**APPLICATION FOR PERMISSION
UNDER SECTION 16 OF
THE TOWN PLANNING ORDINANCE
(CAP.131)**

For Official Use Only 請勿填寫此欄	Application No. 申請編號	A/YL-PH/919
	Date Received 收到日期	28 APR 2022

(a) Proposed use(s)/development 擬議用途/發展	Proposed Temporary Transitional Housing Development with Ancillary Eating Place, Shop and Services and Community Centre for a Period of 3 Years with Filling of Land (Please illustrate the details of the proposal on a layout plan) (請用平面圖說明擬議詳情)

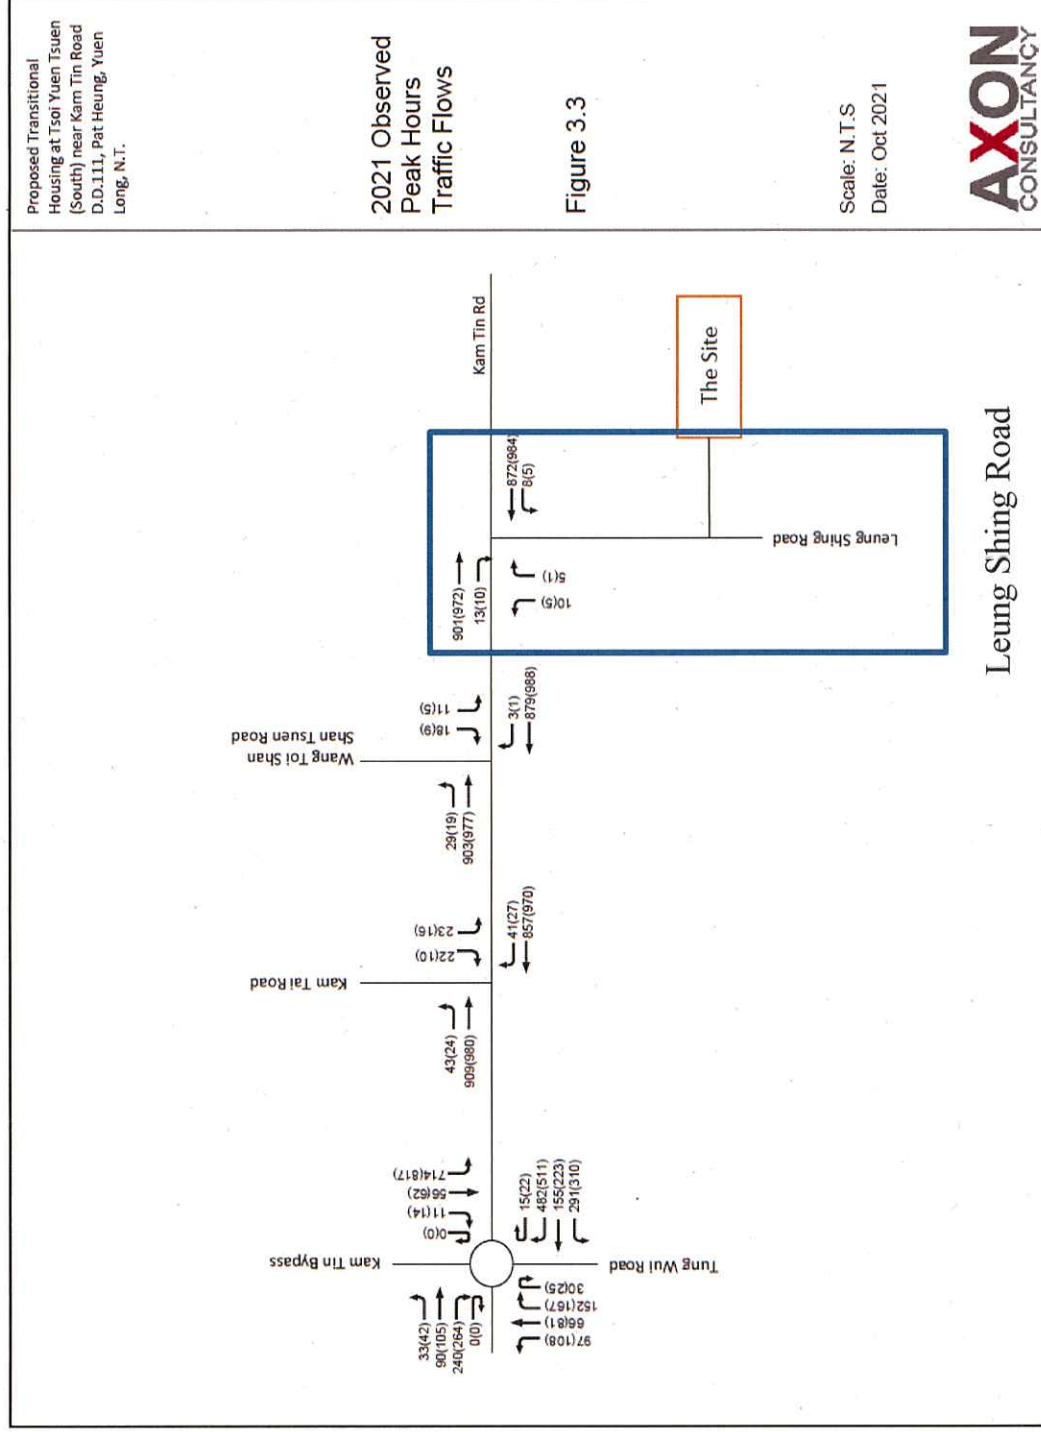
2.	Table 3.3 (a) Some entries under "5-year average" column are missing in Table 3.3. Please supplement. (b) Please clarify which set of AQOs (i.e. AQOs launched in 2014 or prevailing AQOs took effect on 1.1.2022) was used for checking compliance in Table 3.3. Please add a column to show the respective AQOs in the table for clarity. Please also bold the value with exceedance of AQO accordingly.	(a) The 5-year average for the highest 24-hour data has been included in the revised report. (b) The assessment made use of the criteria that are specified in the new AQOs, which are scheduled to become effective on January 1, 2022. In the table, a column displaying the respective AQOs has been added, and the value with AQO exceedance has been bolded.

Appendix C: Relevant EVA Diagram

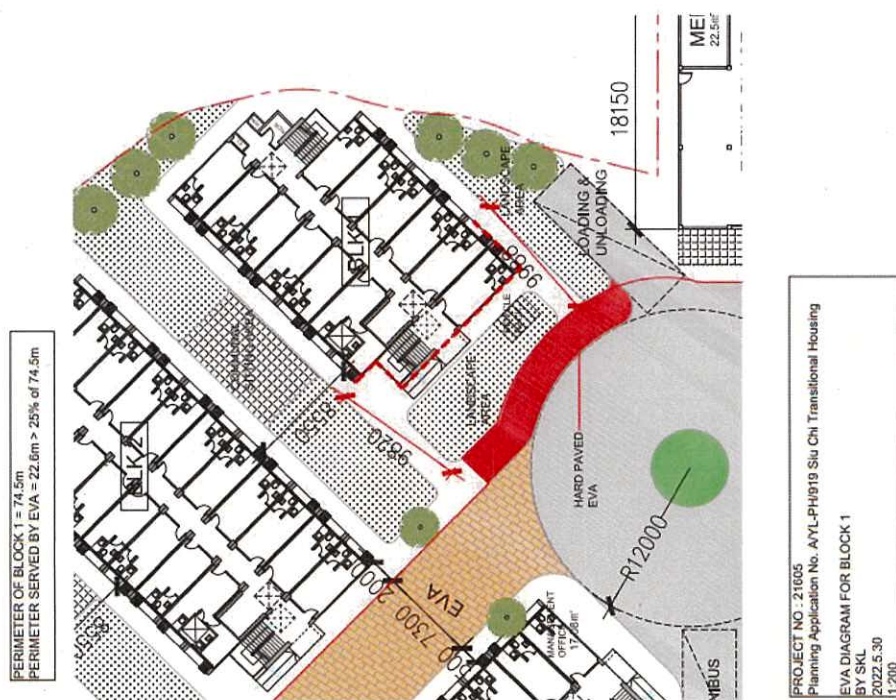
1.	It appears that Block 1 is not served by the emergency vehicular access (EVA). EVA within the Site shall be provided for these blocks in accordance with B(P)R 41D and PNAP APP-136.	We write to clarify the hard paved EVA location and submit relevant EVA diagramme to clarify our intent to include the hard paved area and carriage way as part of the EVA for Block 1. The length of the façade served by the EVA will comply with B(P) R41D and PNAP APP-136. (see Appendix C)
